From: Distel, David J:(GenCo-Nuc) <David.Distel@exeloncorp.com>
Sent: Monday, January 08, 2018 9:07 AM
To: Gibson, Lauren
Cc: Wrobel, George:(GenCo-Nuc); Joe Bellini; Lanka, Bradley Franklin F:(GenCo-Nuc)
Subject: [External_Sender] RE: Ginna FE Audit Info Needs
Attachments: BSD26 REV 0.pdf

From: Gibson, Lauren [mailto:Lauren.Gibson@nrc.gov]
Sent: Thursday, December 21, 2017 4:10 PM
To: Distel, David J:(GenCo-Nuc)
Subject: [EXTERNAL] Ginna FE Audit Info Needs

As I described on the phone today, I was not able to discern the information I need for the evaluation of the FE (ML17069A004) from the documents in the ePortal. I understand that Ginna is relying on the installation of temporary flood barriers. Here are my information needs:

THE PREBRY CORP.
P.F.B22 FLOOD
BARRIER ASSEMBLY
PR11641

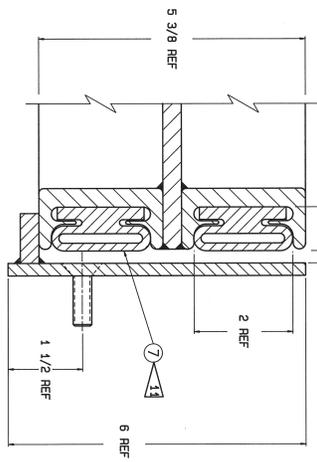
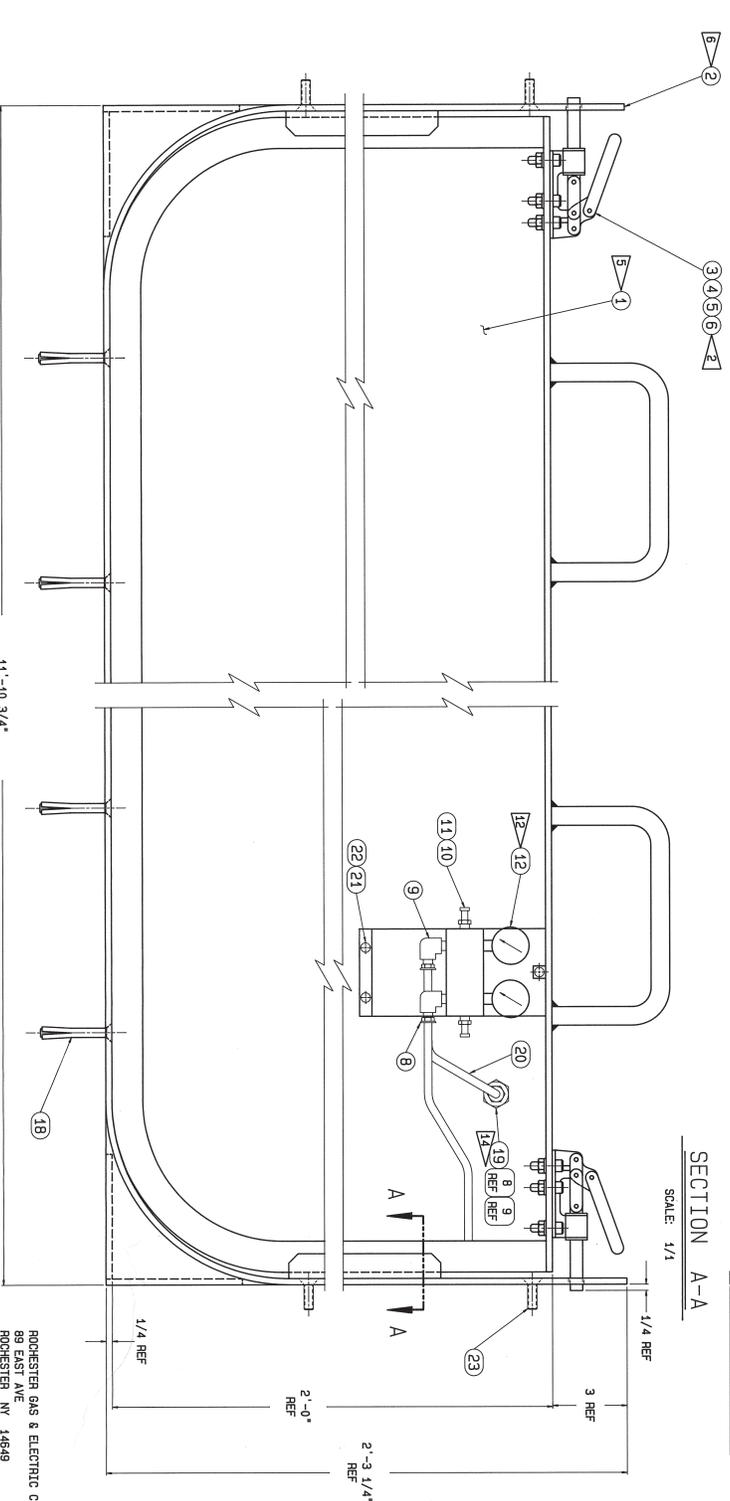
- 1) It's not clear to me in all cases which barriers are going on which doors or structures, or how high the particular barriers are.
- 2) It appears from the audit documents that some barriers are around and in front of areas instead of directly on doors; is there expected leakage past the barriers? How much?

1. Table 7-1: BSD/29F Presray barrier is 3.3 ft. high, flood is 2.7 ft. high. APM is 0.6 ft. BSD/26, 27, 28 Presray barrier is 2.0 ft. high, flood is 1.4 ft., 1.6 ft., and 1.6 ft. high, APM is 0.6 ft., 0.4 ft., and 0.4 ft. Attached is a typical drawing of the Presray door seals.

2. Portable Presray barriers fit into channels at the doors. Sealing surfaces are flexible, and filled with air after installation for a tight fit (i.e., no leakage).
